APPENDIX A. Consultation Comments Tracker

Water Eaton (23/01233/OUT) – Consultee Comment Review

PR6a, North Oxford

drawing no.	42	drawing	Illustrative Masterplan	
revision	T	scale	1:5,000 @A3	job no. 477898
drawn by	AR	checked by	RL	date 17/01/2024

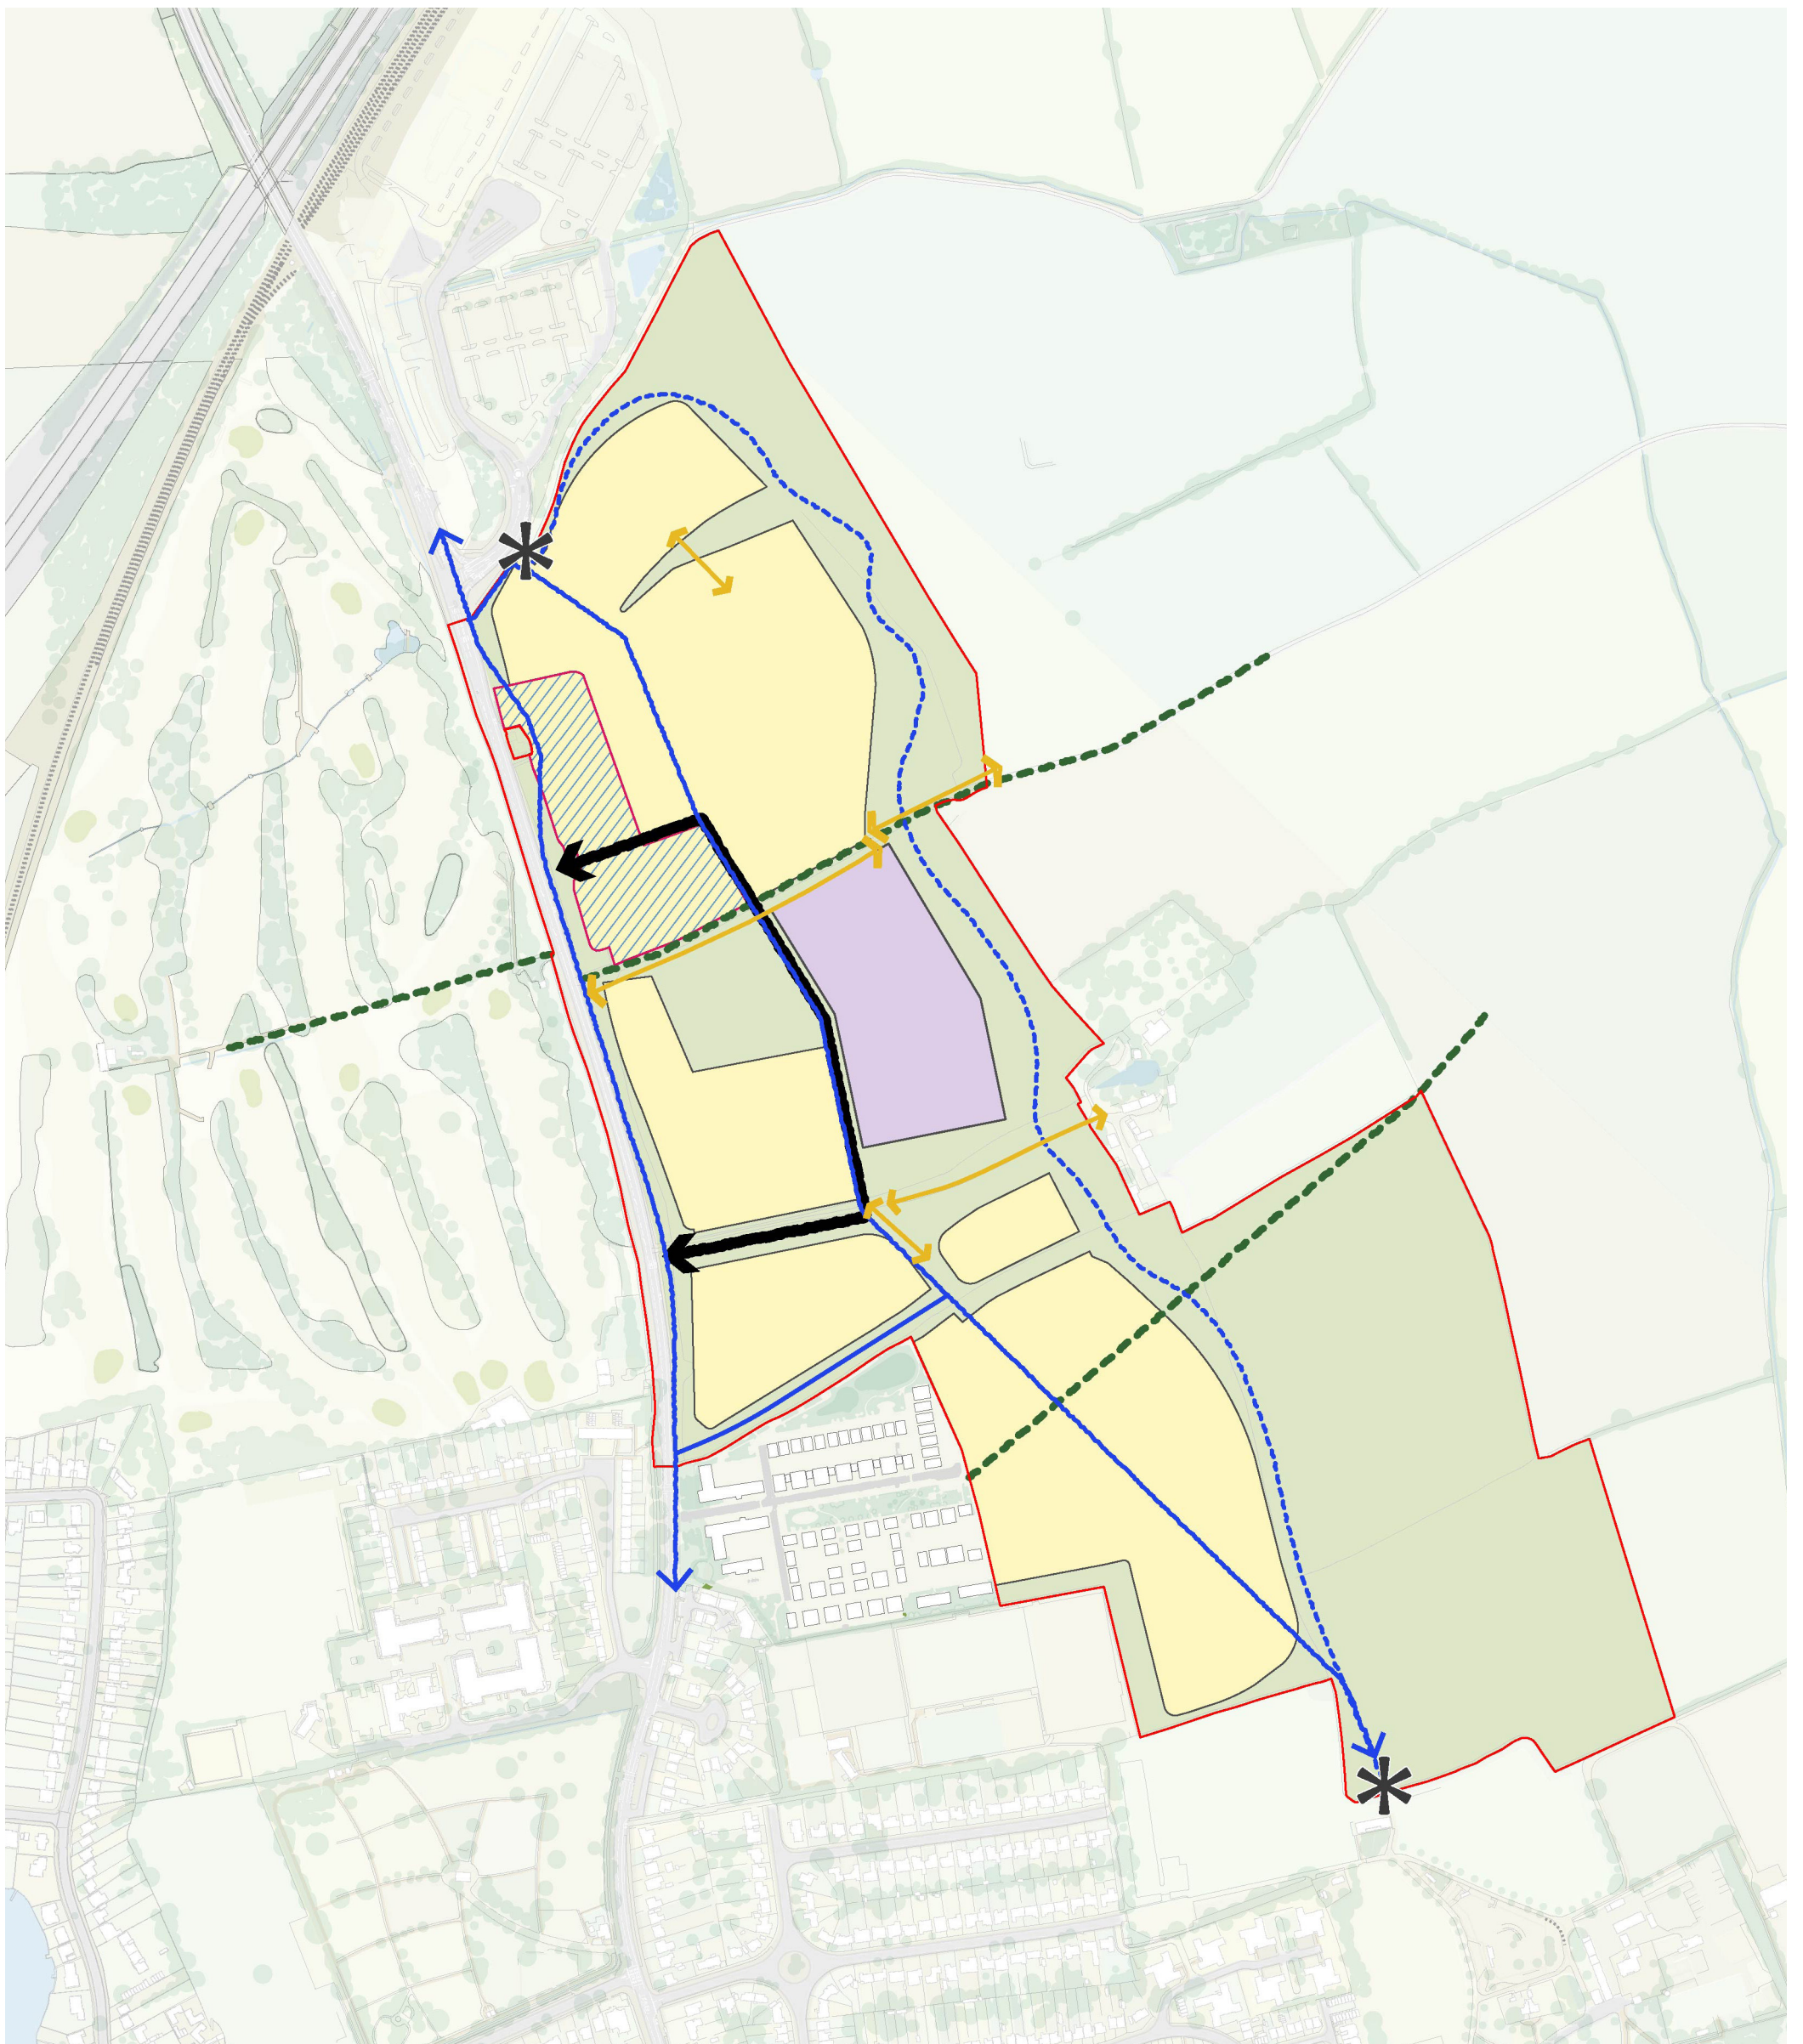
Consultee	Comment	i-Transport Response
	<p>PRoW - It is imperative that the development connects the existing PRoW into the Croudace Scheme. However, your attention is drawn to the fact that the PRoW on the illustrative Masterplan may not be in the correct place. This needs to be discussed with Croudace at the earliest.</p>	<p>Addressed in Transport Assessment Addendum and updated Design and Access Statement.</p>
<p>Gosford and Water Eaton Parish Council – 7 June 2023</p>	<p>Parking: Objection - lack of provision. Where are these people going to park, where are cycle bays going to be? Are the kerb heights and road widths going to allow roadside parking? Parking enforcement would also need to be clarified. Parking provision for flats is not enough at all. No electric charge points provided, and they need larger spaces. Needs consideration on who will monitor parking and manage electric parking spaces.</p>	<p>This is an outline planning application. A parking assessment is provided at Section 4 of the Transport Assessment Addendum demonstrating that car free development is not appropriate. Oxfordshire County Council's response agrees that cycle and car parking will be agreed under reserved matters applications.</p>
